PDP8L

Engineering Change Order Log

ECO SYNOPSIS FOR LOGIC OR OPTION
PDP-8L PROCESSOR LOGIC **PDP-8L**

ONLY FCO'S WRITTEN TO THE "PDP8L" OPTION ARE DOCUMENTED ON THIS FICHE.

D-BS-8L-0-2

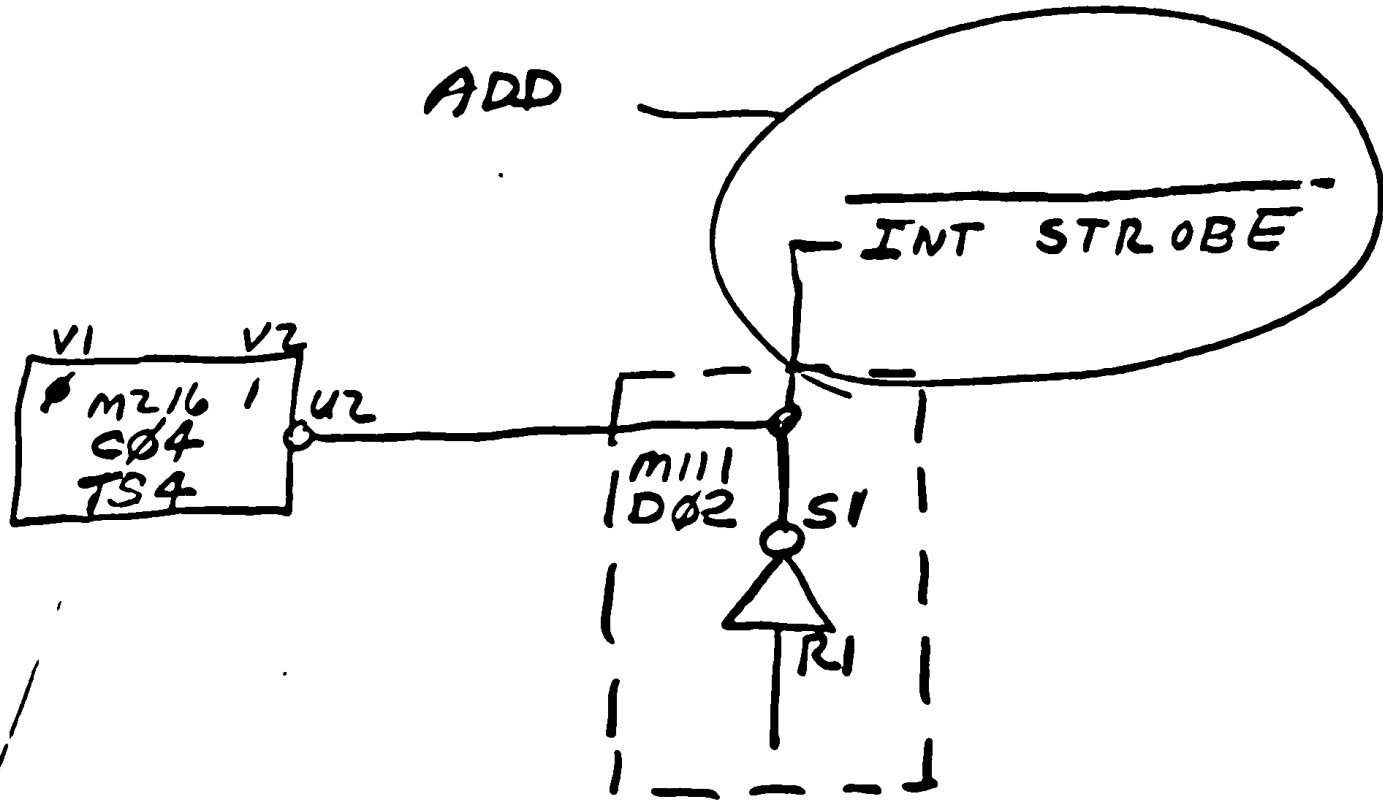
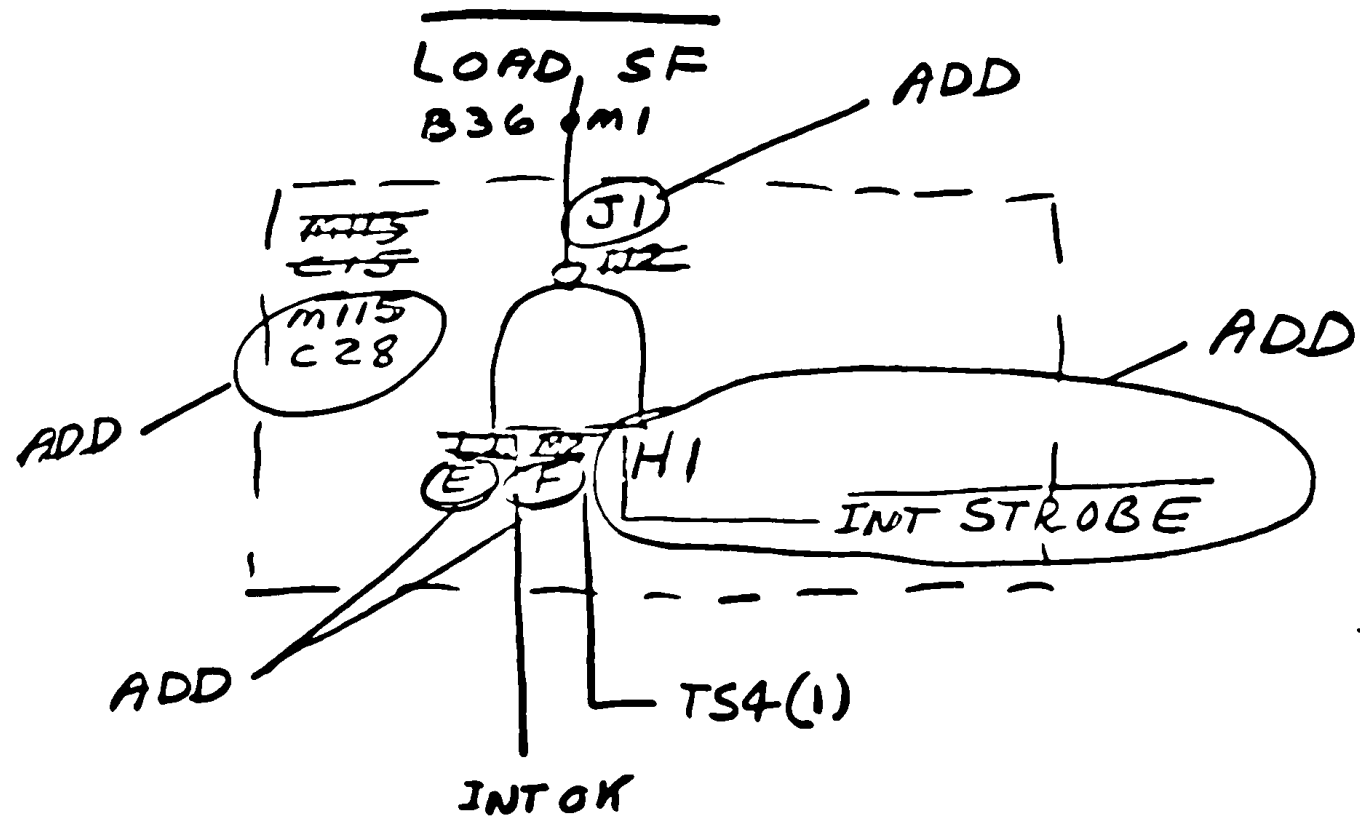
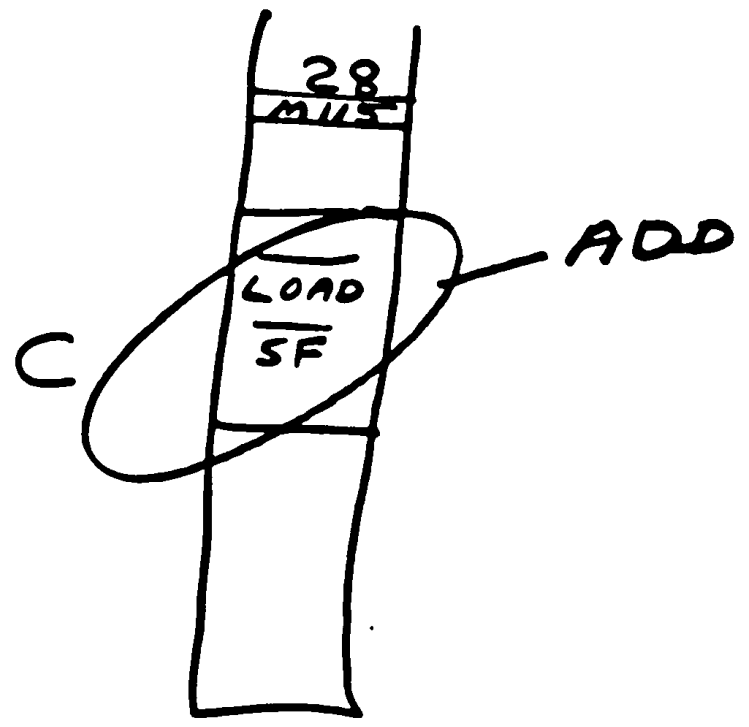
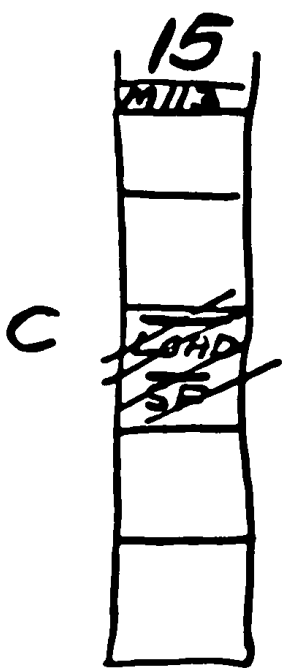
- When program is running in upper memory with the interrupt on, and an interrupt occurs during an IOT the program never gets restored to upper memory with an RNF (load SF clears each FF during interrupt)
- Wire list errors - prints are correct

- Gate INT strobe to the load SF gate
- Change wire list to agree with prints - reference D-BS-8L-0-6

Title					Tech Tip				
8L AFFECTED BY EXTERNAL NOISE					Number				
Processor Applicability					PDP8L TT#7				
All					Cross Reference				
Author					Rev				
W. Freeman					g				
Approval					Date				
W. Cummins					11/11/73

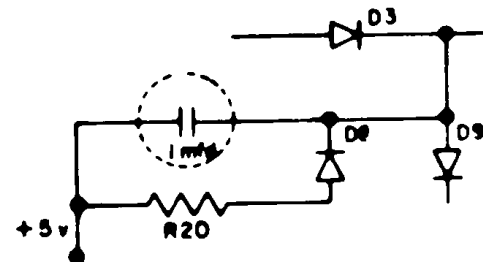
If external noise from surrounding equipment is affecting an 8L, the installation of a .1 mfd. capacitor on the G785 module as shown in the schematic below will resolve the problem.
